Errata Sheet

9 July 2001 / Release 1.4

Device: C515C-8E
Stepping Code / Marking: BB
Package: P-MQFP-80

CAN.4: Flowchart sequence in figure in User's Manual regarding Micro-controller handling of the Last Message Object is partly incorrect

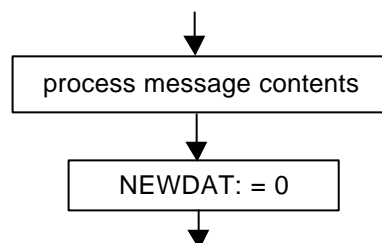
For the software flowchart figure 6-48 in User's Manual 11.97, the correct would be to first 'process message contents' and then to 'clear bit NEWDAT'.

This correction will be updated to the future versions of the User's Manuals.
